kampus listed

design + access statement addendum
appendix • post NMA application changes

04.01 ext 22 • projecting window sleeve to rear elevation

fig 91: minshull house rear elevation - amended demolition elevation

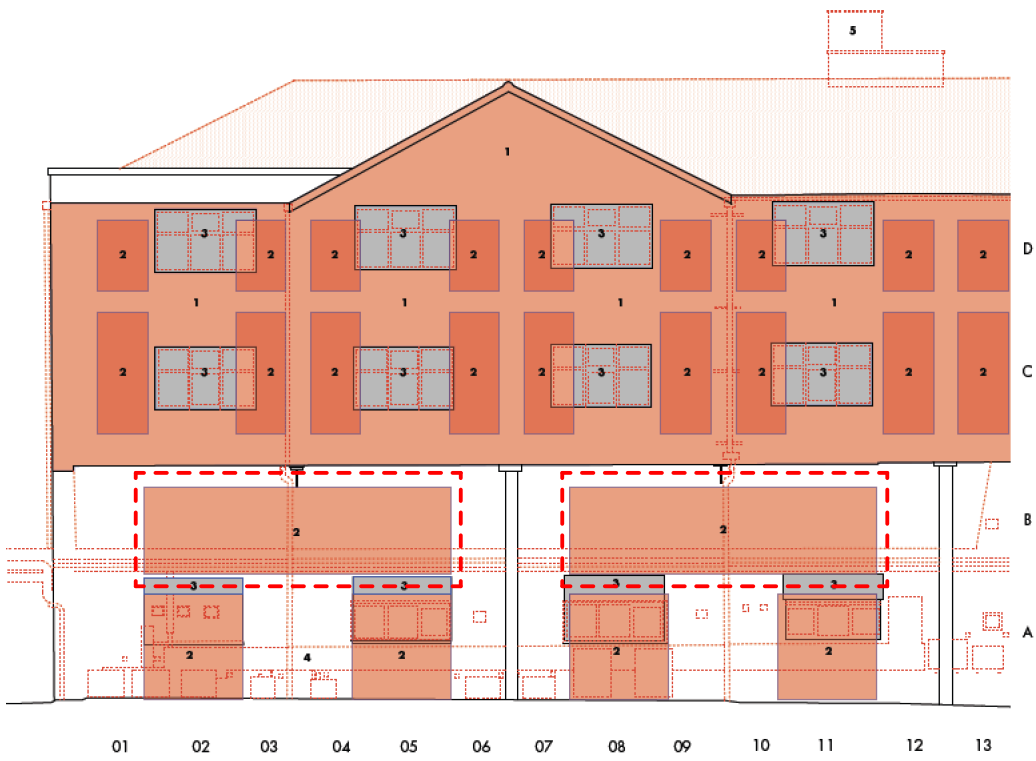
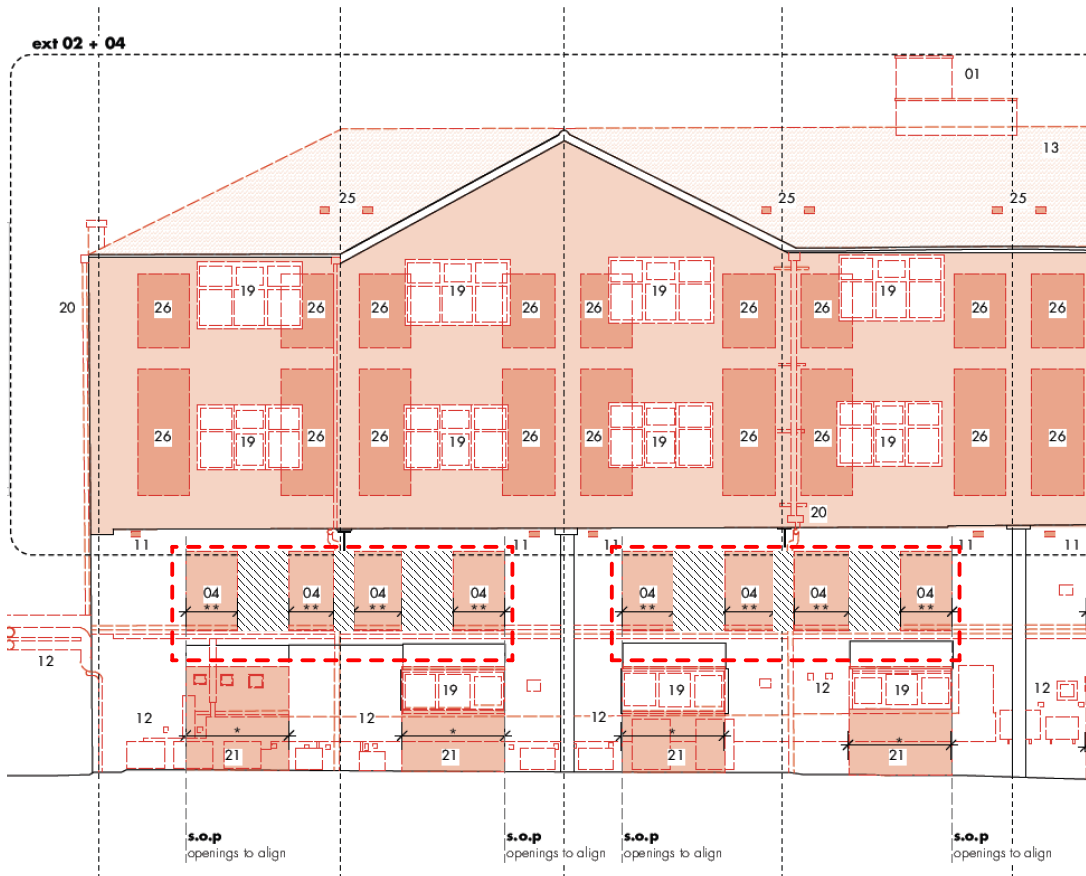
Change: Introduction of projecting sleeve to the level 01 windows on the rear elevation of Minshull House.

The original planning stage proposal involved the demolition of a much larger area of existing brickwork and the introduction of a large steel beam to the head of the windows. There was concern from the Structural Engineer about the proximity of the steel to the existing cast iron cantilever structure and the amount of existing brickwork proposed for removal. They advised that a series of piers were retained for stability/robustness of the facade.

In order to maintain the continuous window system approach, the design team introduced a similar approach to that referenced under external change 06 (refer 02.06), whereby overcladding panels to the retained brick piers were introduced with a projecting powdercoated aluminium sleeve to maintain depth to the reveals

Approved by MCC at site inspection on 14.07.21.

fig 95: minshull house rear elevation (levels 00) - tenant signage parameter proposal

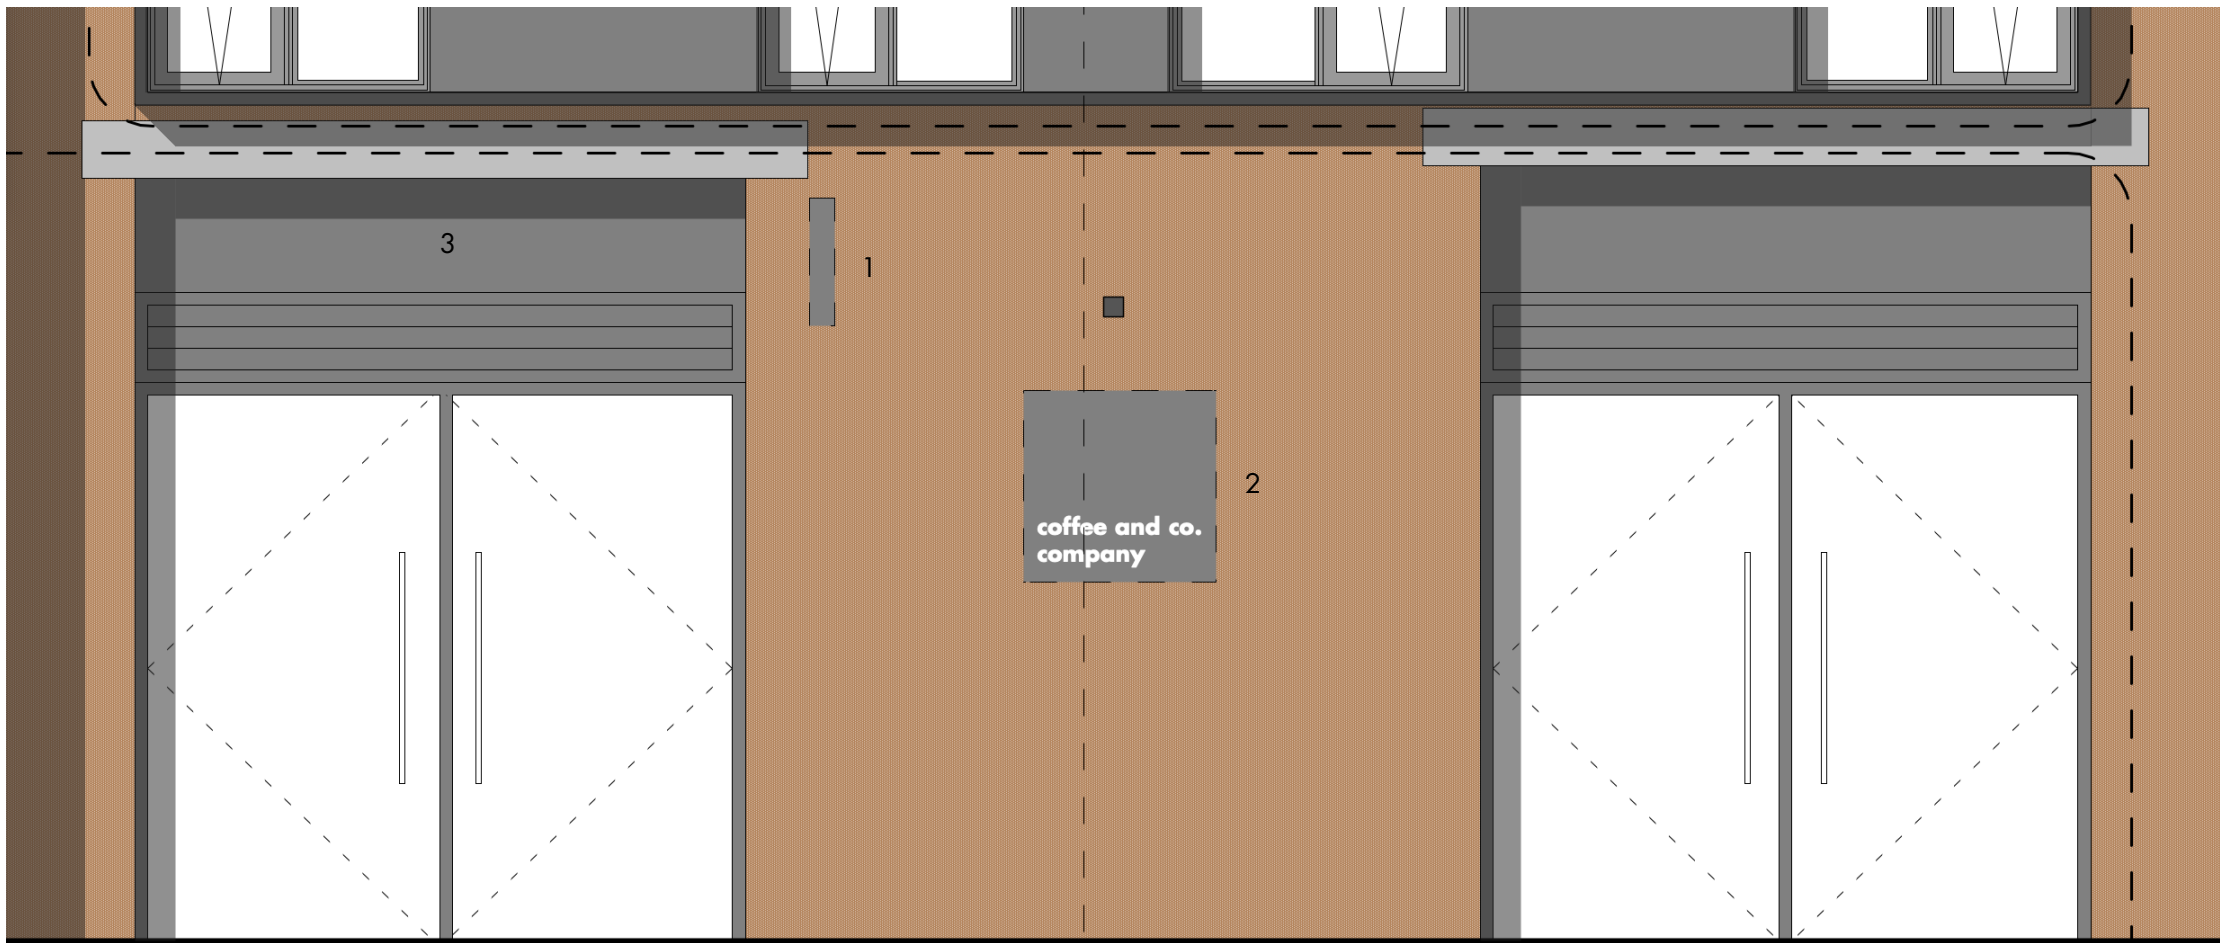
Change: Omission of the projecting signage canopy to the rear elevation of Minshull House.

Following pull-out tests undertaken by the facade subcontractor, it was determined that the existing brickwork would be unable to support the proposed canopy extension of 1 metre. Further advice from the facade contractor's engineer clarified that the largest projection the brickwork could support was c.250mm. Through discussion with the client group and MCC, the team have omitted the box signage from the proposals entirely and provide a powdered coated aluminium fascia panel above the louvres for potential tenant signage opportunity. This strategy was considered to be advantageous from a conservation perspective as more of the existing fabric would be left exposed, and the stone section to the right hand side of the elevation would be more visible.

In order to allow prospective tenants with signage, the team have now put indicated signage parameters on the elevation for bus stop and facade mounted signage. Each unit will be afforded 2no. of each to allow for a potential unit split at a later date. Further details of signage to be submitted under Condition 28.

Approved by MCC at site inspection on 14.07.21.

fig 100: developed mvhr vent detail for install

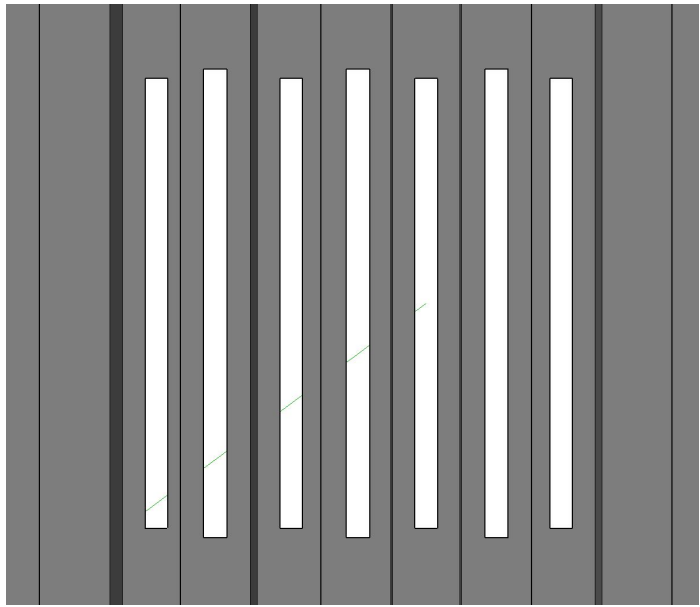
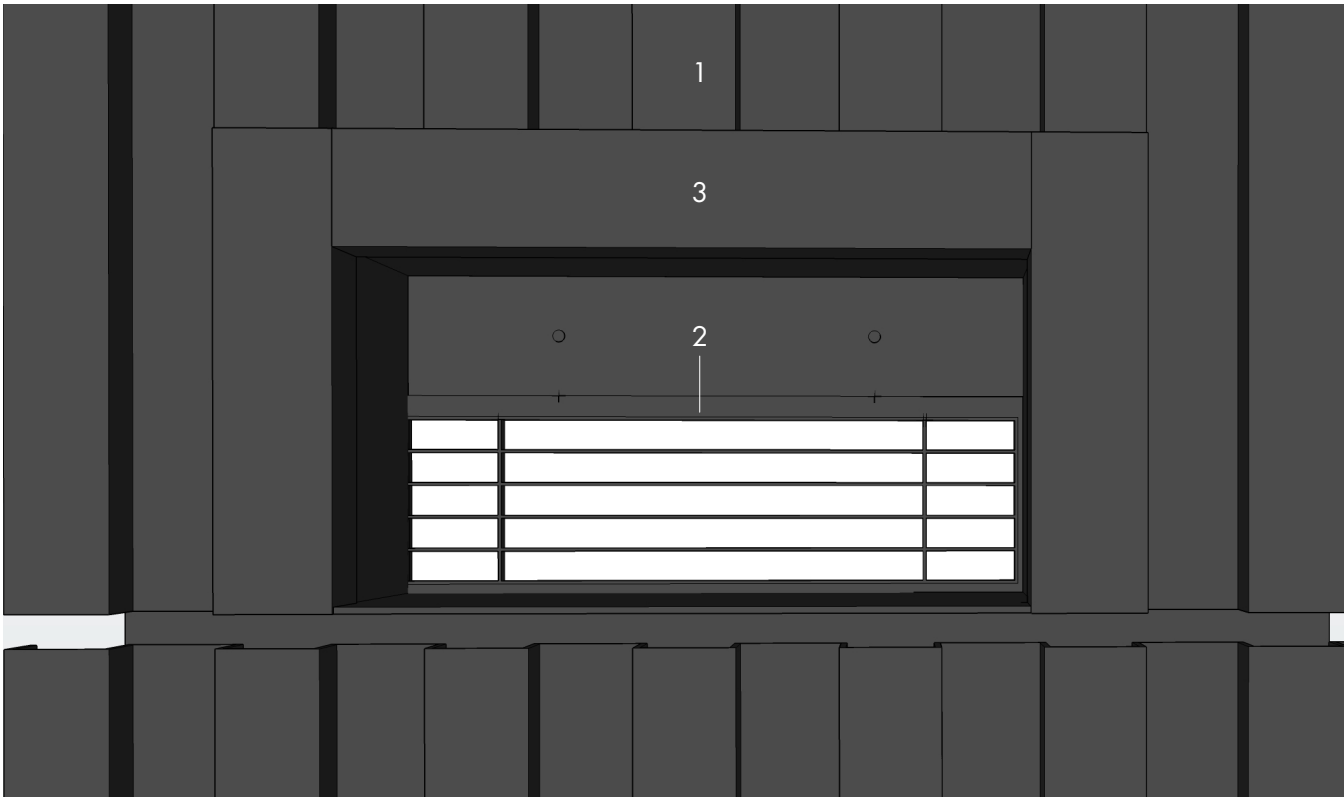
Change: Refinement of the design to the MVHR vents in the new profiled aluminium cladding to the rear elevation of Minshull House.

Following change to the window design (refer change ext 09) the mvhr vents to the rear elevation needed to be moved to the facade. An intent submission was made under Condition 33h (LB Condition 6h) that proposed ventilation slots were to be integrated into the pitches of the cladding (refer fig.99).

During design development with the facade subcontractor, the team were advised that the vent panel size would need to increase to allow the required air flow and therefore there were concerns regarding panel robustness and visibility.

A new approach was developed wherein a facade plenum would be installed with an inset grille to the required free area. This approach halved size of the original vent detail. All elements are also colour matched to the cladding; further reducing their visual impact.

Approved by MCC at site inspection on 14.07.21.
